Service Bulletin

NUMBER 29004 0001

COACH
SPECIFICATIONS

2900R

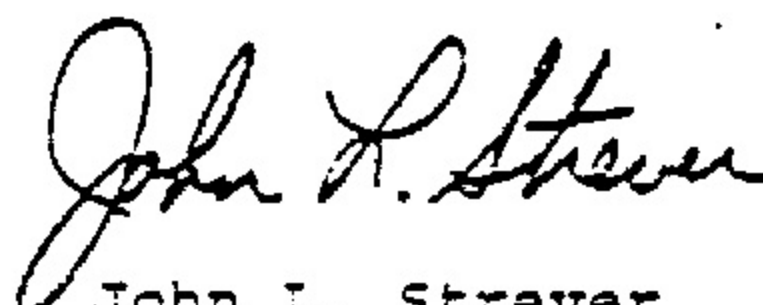
Under paragraph entitled AIR CONDITIONING change automotive BTU Output Maximum (A/C unit) to 28,000 BTU Output-Maximum (heater/defroster) to 36,000, and Domestic BTU Output-Maximum (dual units) to 22,000.

Under paragraph entitled DOMESTIC EQUIPMENT add under Furnace the BTU input of 30,000 and the BTU output of 22,500.
